Access Compliance Report

## Public Rights-of-Way
(Curb Ramps)

Intersection ID: 19665	**Main Street:** BROWN-GRIER_RD	**Cross Street:** WILD_DOGWOOD_CT	**Location:** NE
ADA ID: 47F091676881	**Ramp Type:** PerpDiag	**Initial Pass/Fail:** Fail **Overall Compliance:** No	**Severity Score:** 12.5

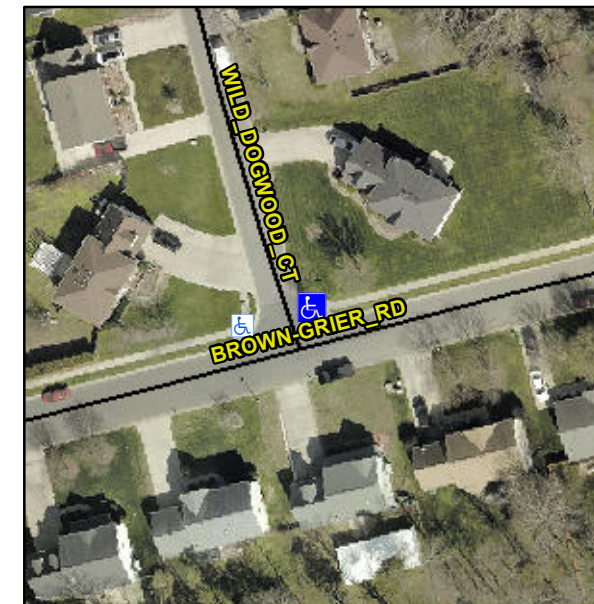
Remove & Replace Curb Ramp With Two New Directional Ramps or Equivalent.

R304.5.3
